CORRIGENDUM - 018/01

Sub :NAME OF WORK: DIVERTING ELECTRICAL LOADS OF MAIN CAMPUS FROM NILA CAMPUS, PROVIDING ELECTRICAL SUPPLY TO NEWLY PROPOSED DATA CENTRE OF SAMGATHA BLOCK AND PROVIDING ADDITIONAL STANDBY FACILITY FOR ELECTRICAL LOADS OF AGORA, SAMGATHA AND NEW DATA CENTRE TO SYNCHRONISING PANEL OF 500 KVA AND 250 KVA DG SET AT IIT PALAKKAD

Ref: 17/IITPKD/EWD/ELE/2024-25/018, dated 14.08.2024

SLD OF THE PROPOSED WORK

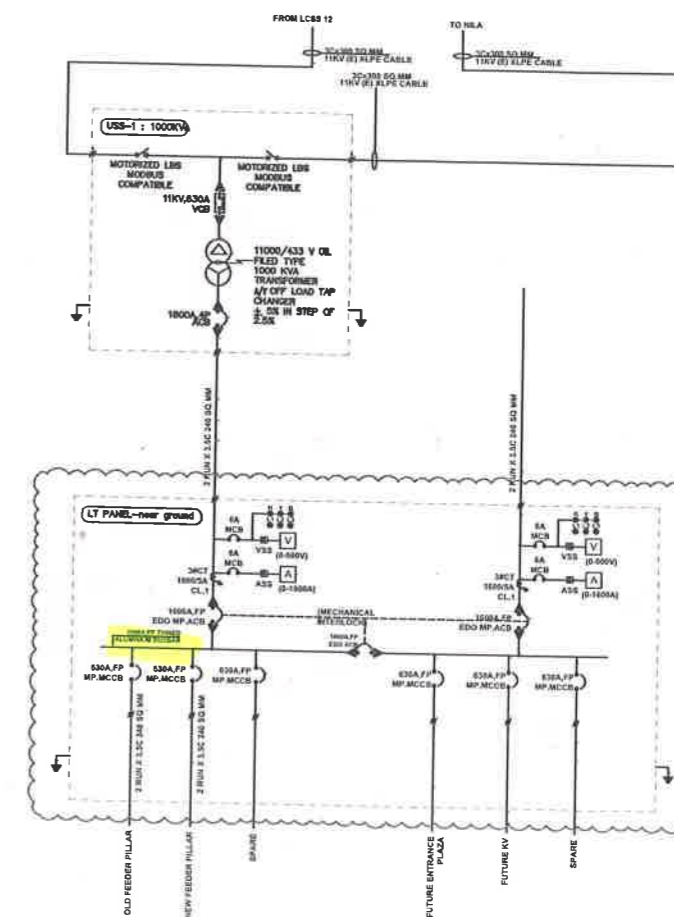
SI No	Existing Entry	To be read as
1.0	Attached Single Line Diagram - bus bar is copper. In schedule of work item no. 01, 02 and 03 bus bars are aluminium.	Aluminium bus bar as per schedule of work.
2	Make of MCCB in List of preferred make sl.no. 02 - Legrand -DX3 / Schneider -NSX / Siemens 3VL	Make of MCCB - Legrand -DX3 / Schneider -NSX / Siemens 3VL / L&T d-sine
